## SFF-8614

### Mini Multilane 4/8X Shielded Cage/ Connector (HDsh)

Rev 3.5.4

~~June 11, 2026~~ July 10, 2023

Figure 7-17-1 Plug Paddle Card

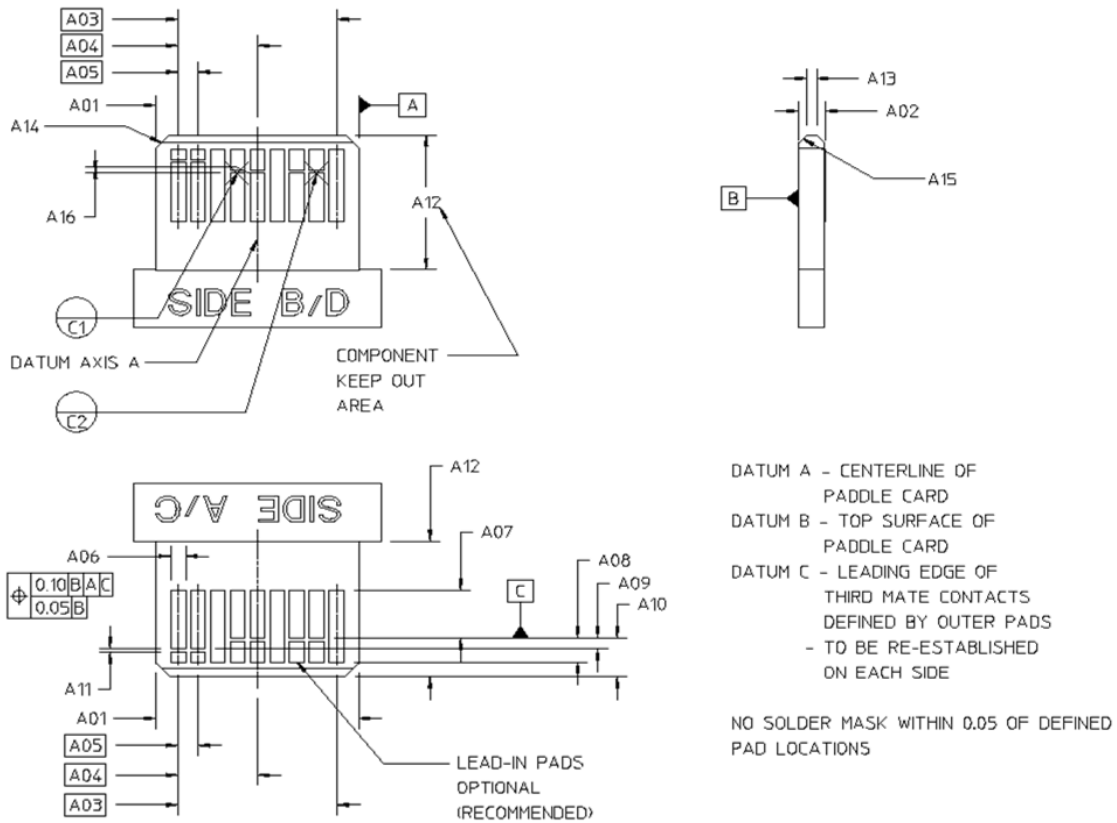
- 1 - Fixed B14 value and naming of B14 and B15
- 2 - Deleted new value of A08, A09, A10 (reverted to original value).
- 3 - Tightened value of A07 and B16
- 4 - Added (e.g., for PCIe 5.0) to note 2 of Table 7-1 and 7-2
- 5
- 6

1. Dimensions prior to revision 4.0
2. New designs should use the updated dimensions for A07 in addition to B16 for improved signal performance (e.g., PCIe 5.0).
3. New designs should use the updated chamfer of 0.30 mm for A14

**Figure 7-27-2 X4 Plug**

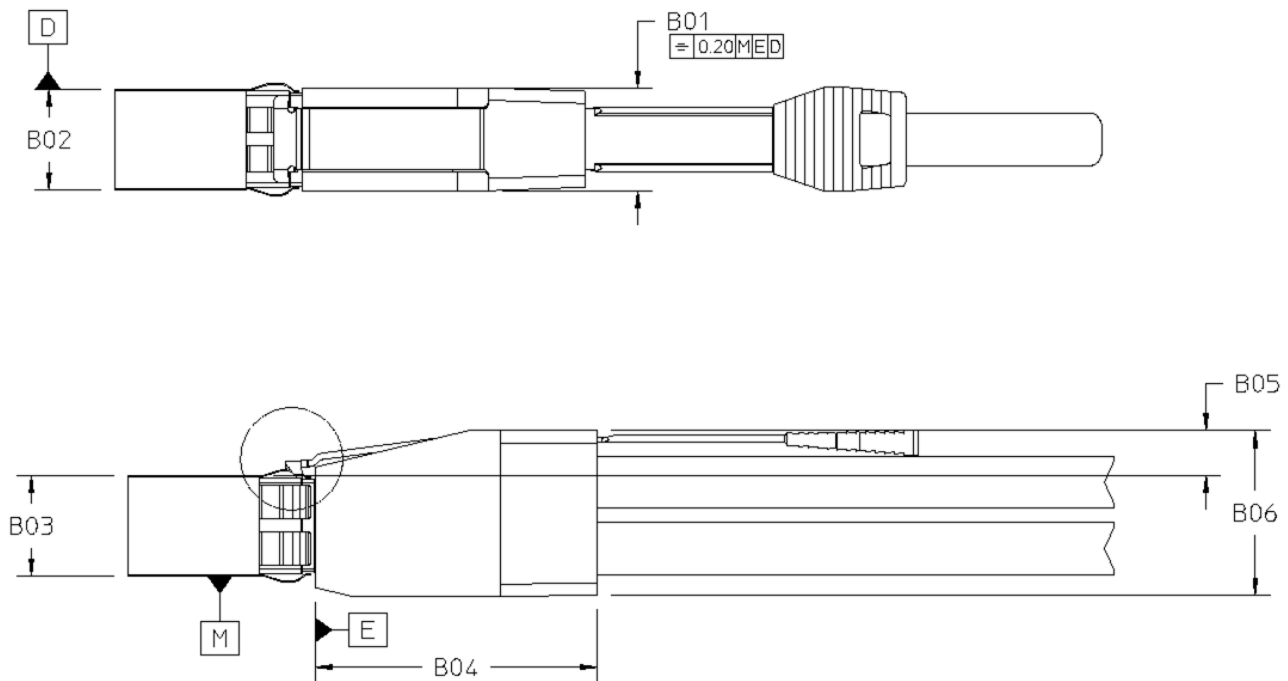
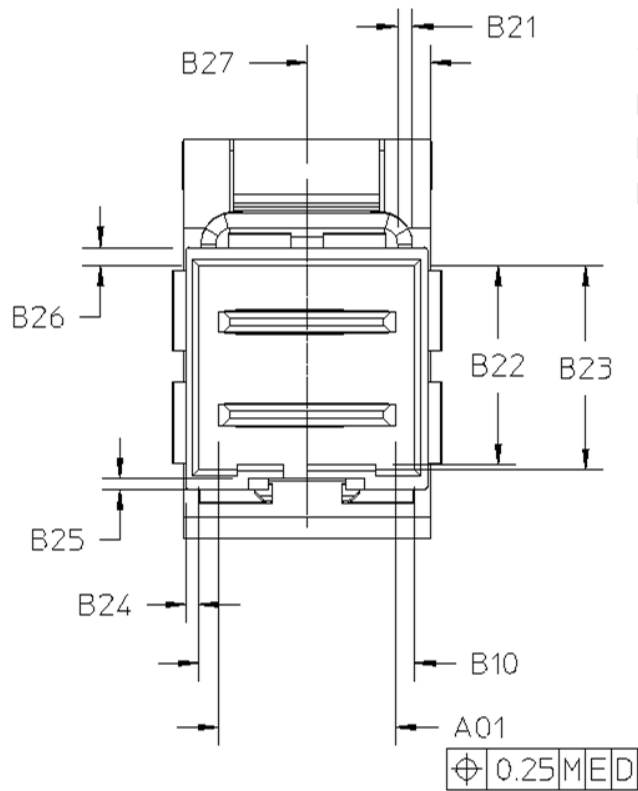
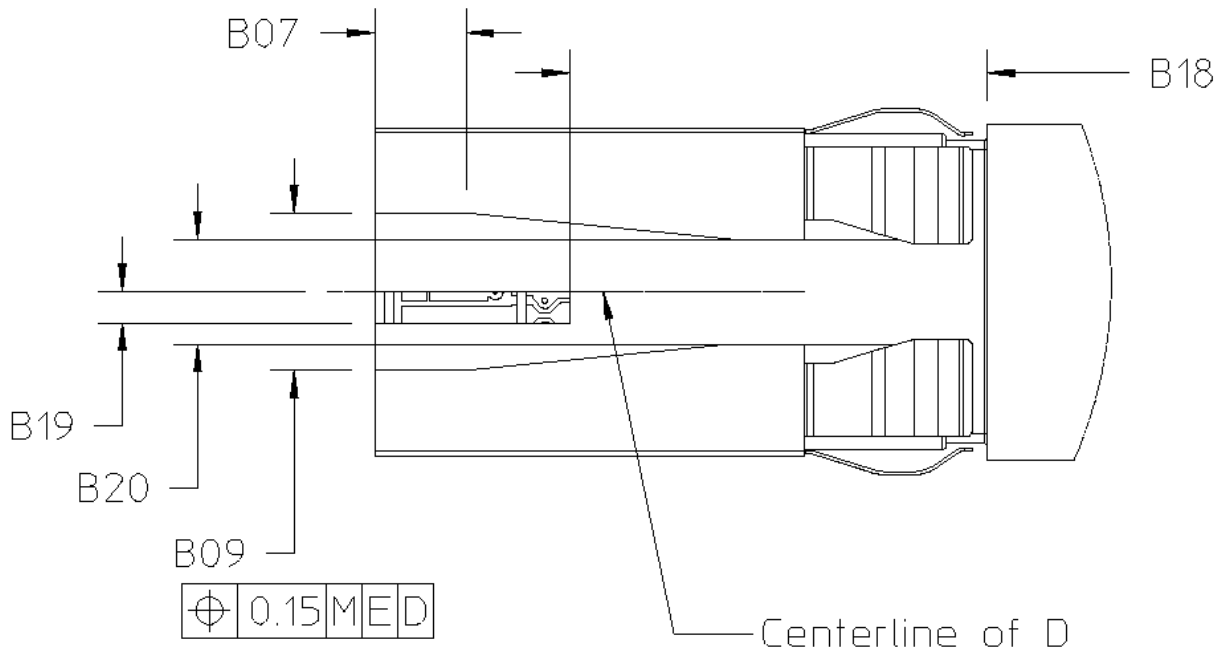
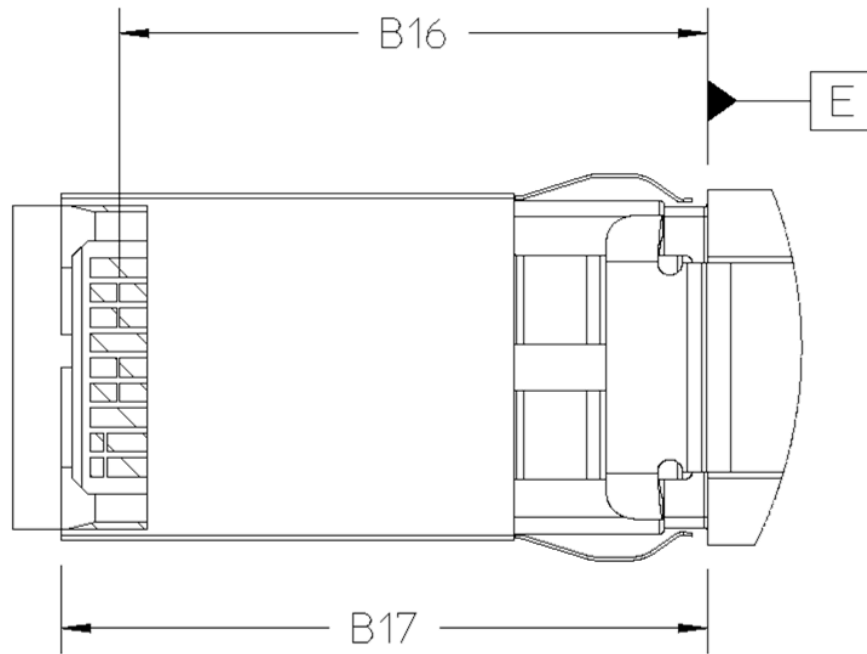
| <p><b>Notes:</b></p> <p>1. <u>Dimensions prior to revision 4.0</u></p> <p>2. <u>New designs should use the updated dimension for B16 in addition to changes for A07 for improved signal performance (e.g., PCIe 5.0).</u></p> |                     |      |      |
